ADDENDUM No. 3

PC26-023 CDBG-DR Hometown Revitalization Program – Truesdell Facility

June 26, 2026

SHEET NO.
EJ.1.01

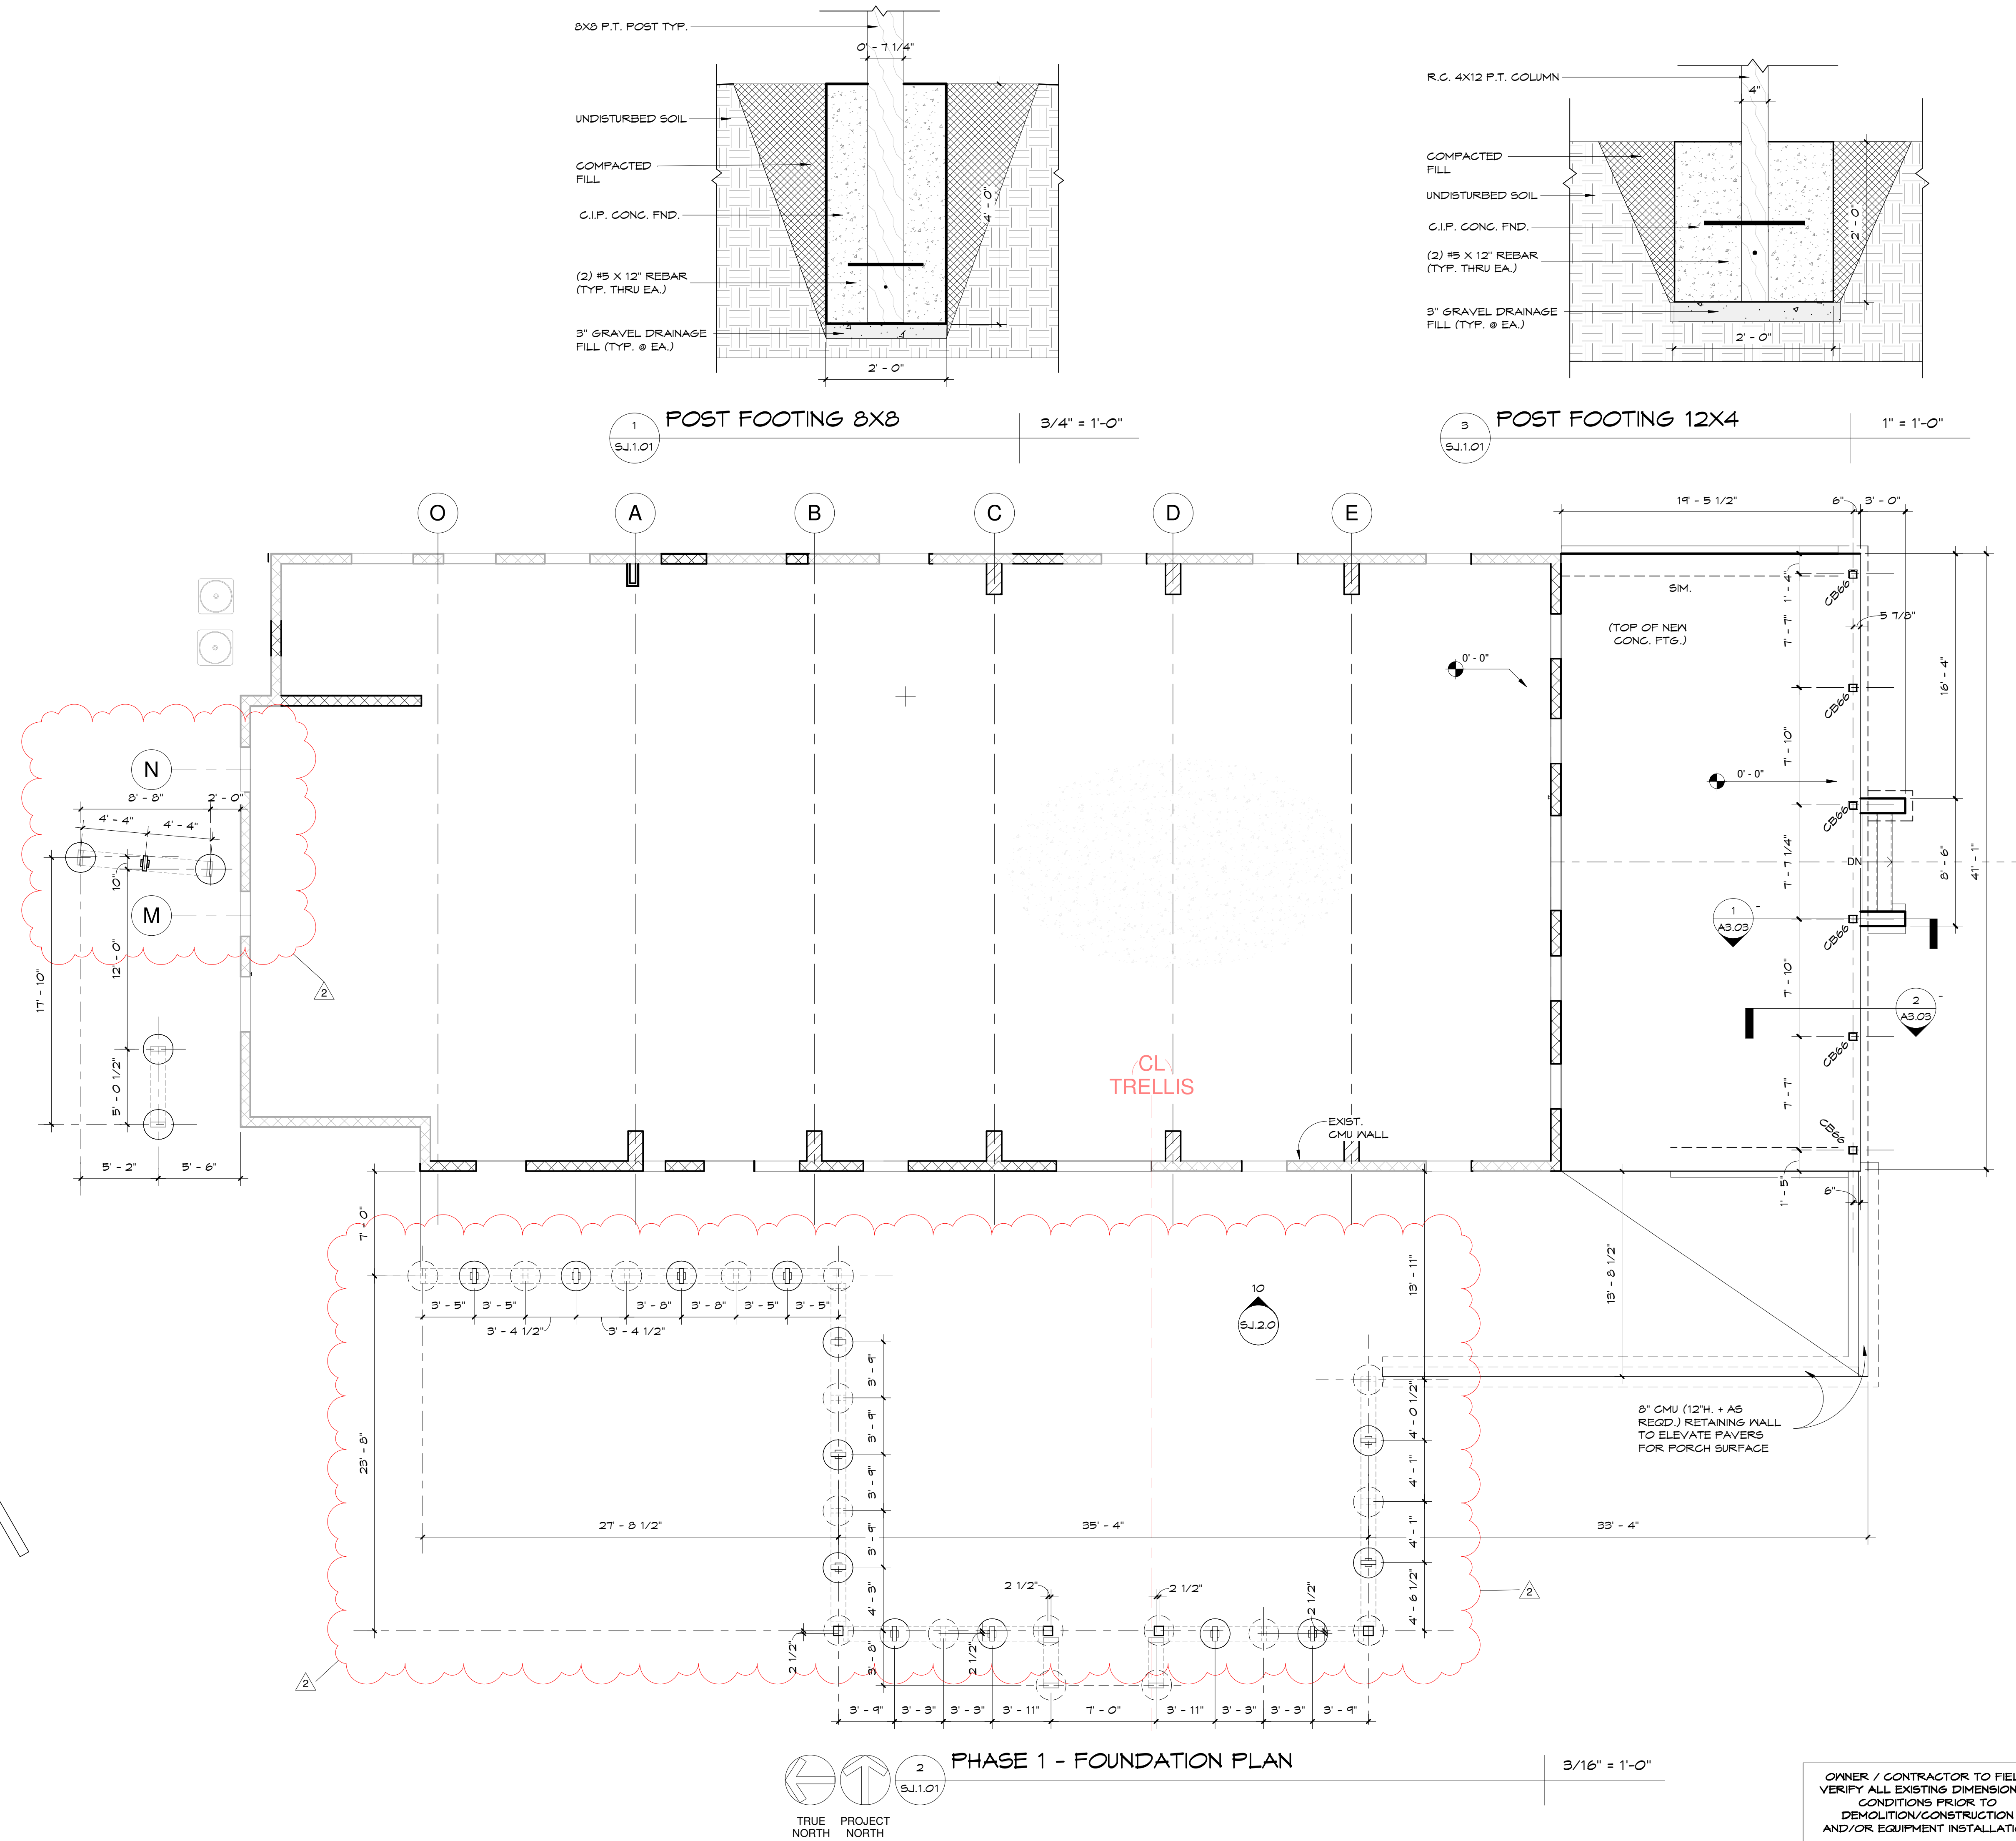
6. **RFI:** Do the privacy screens on the south and east elevations need additional intermediate post to prevent slat bowing?

RESPONSE: Intermediate posts and footings added to privacy screens; refer to drawings attached to this addendum for revisions to fencing and fence lighting.
